**PALM BEACH COUNTY  
PLANNING, ZONING AND BUILDING DEPARTMENT  
ZONING DIVISION**

**Application No.:** PDD/CA/W-2021-01361  
**Application Name:** Atlantic AGR Commercial and Self Storage  
**Control No./Name:** 2021-00083 (Atlantic AGR Commercial and Self Storage)  
**Applicant:** Pebb Atlantic II LLC & SOCRO LLC  
JDR Development, LLC - Jason Sher  
**Owners:** Pebb Atlantic II LLC &  
**Agent:** WGINC - Jeff Brophy  
**Telephone No.:** (561) 687-2220  
**Project Manager:** Timothy Haynes, Senior Site Planner

**TITLE:** an Official Zoning Map Amendment **REQUEST:** to allow a rezoning from the Agricultural Reserve Planned Unit Development (AGR-PUD) Zoning District to Multiple Use Planned Development (MUPD) Zoning District

**APPLICATION SUMMARY:** The proposed requests are for the 9.89-acre Atlantic AGR Commercial development. The site is currently vacant, and is a Preserve Parcel for the Sussman AGR-PUD.

**Figure 4 – Preliminary Regulating Plan (1 of 2) dated July 15, 2022**

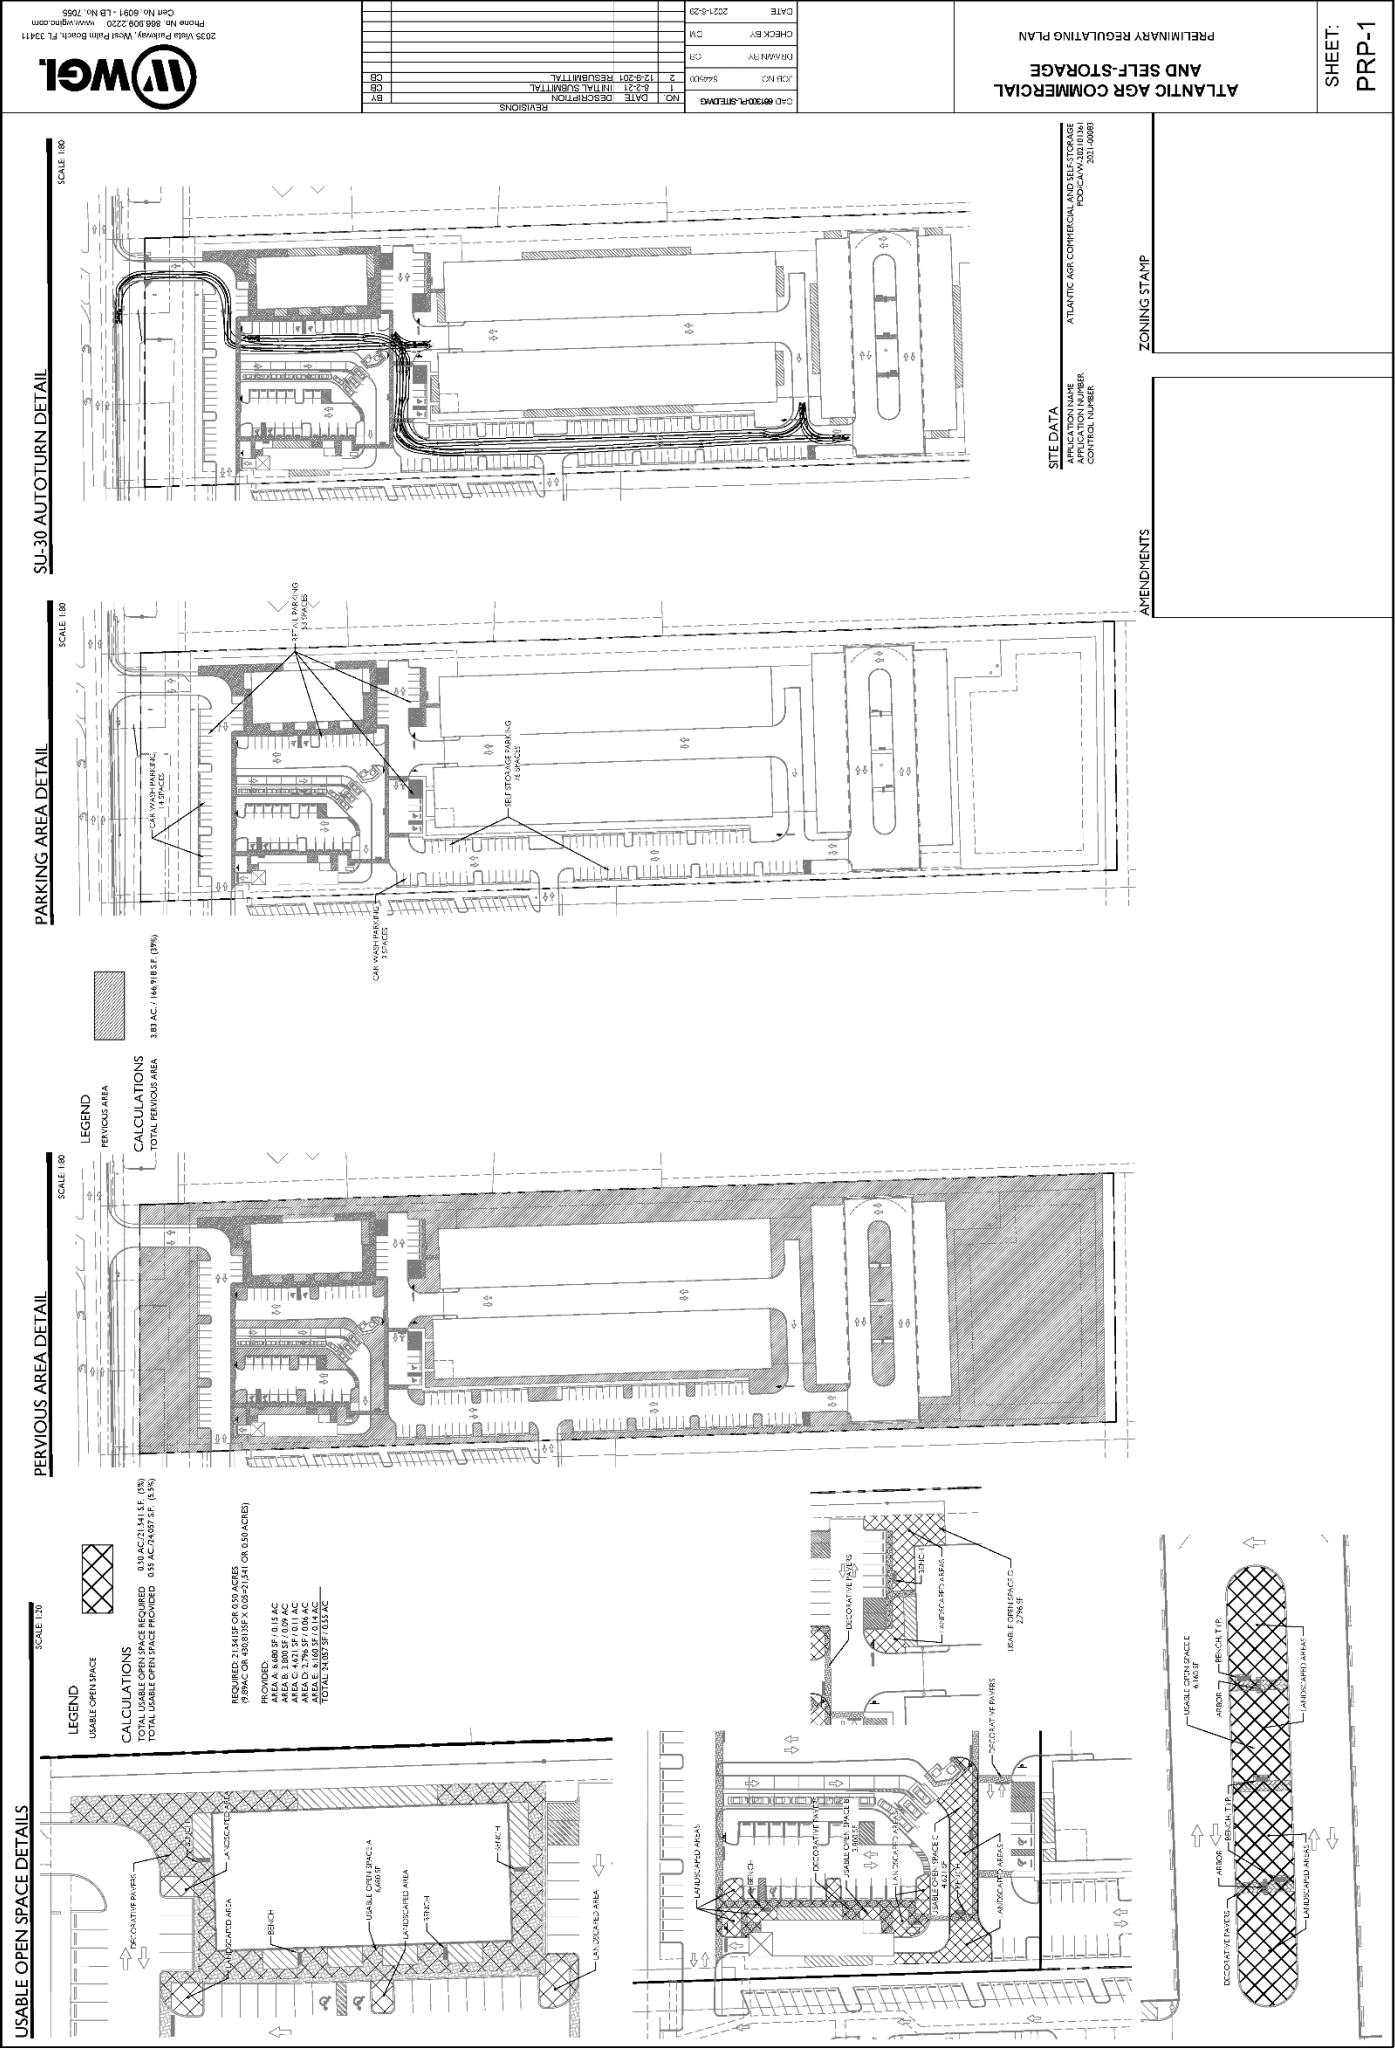
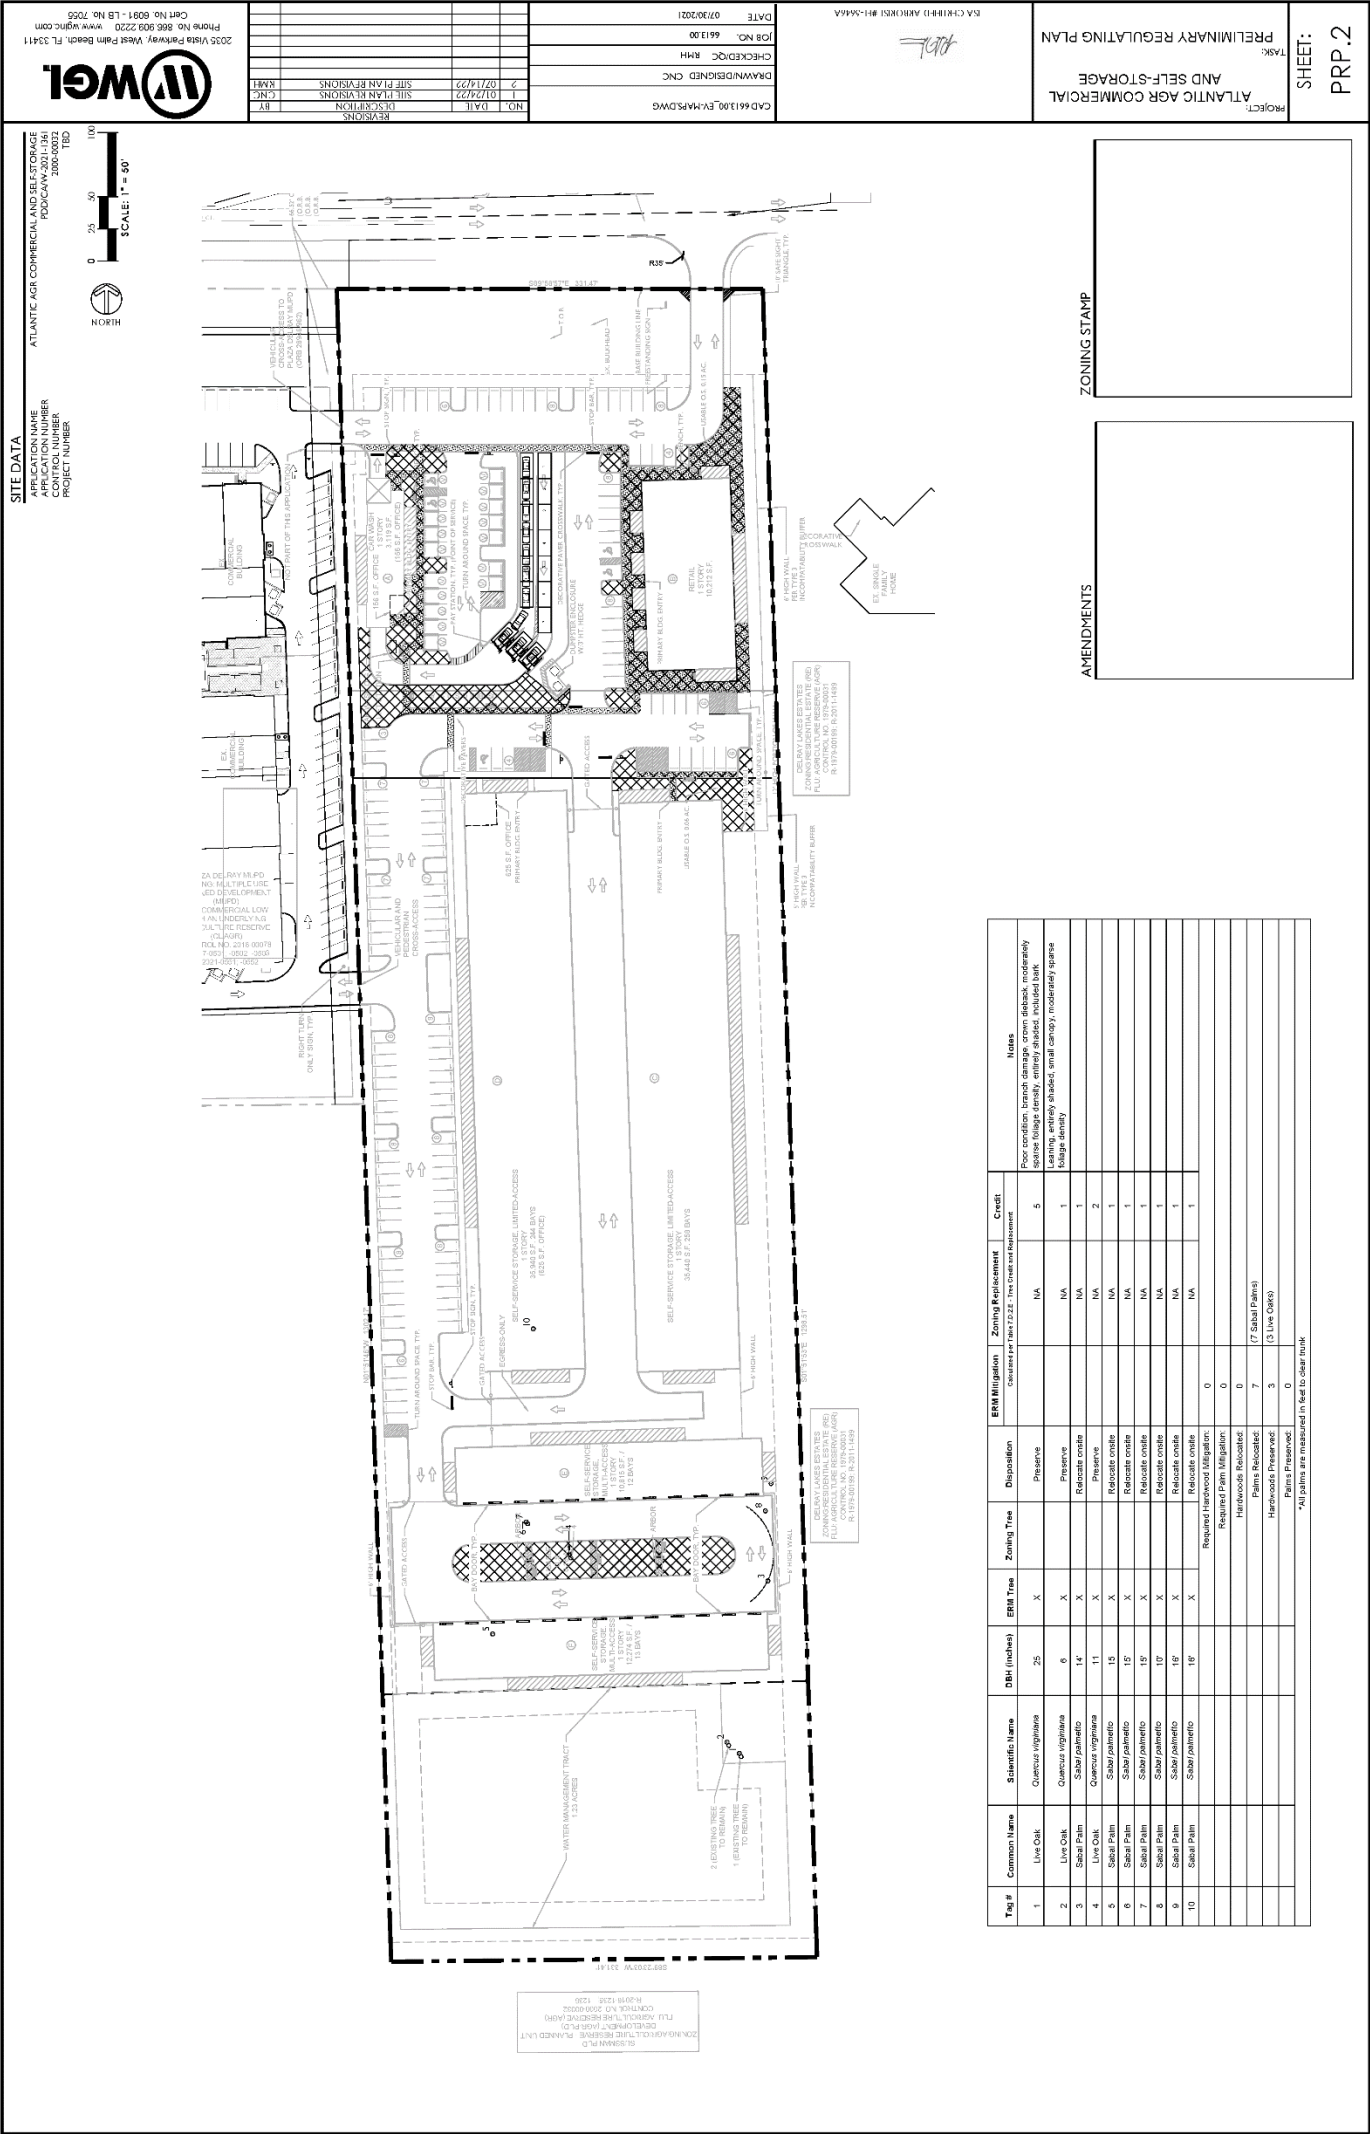
The Ag Reserve Design Elements pursuant to FLUE Policy 1.5.1-r requiring 5% open space has been satisfied with the incorporation of 24,057 sq. ft. or 0.55-acres of Useable Open space for pedestrian gathering areas as indicated on the Useable Open Space area breakdown on the Preliminary Regulating Plan (PRP-1) of Exhibit 4. Staff is recommending a Condition of Approval that the Site Plan be updated to indicate all Useable Open Space areas consistent to what is provided on the PRP.

2. Prior to final Development Review Officer (DRO) approval, the Site Plan shall be modified to indicate all Useable Open Space areas and acreages consistent to what is provided on the Regulating Plan. (DRO: ZONING - Zoning)
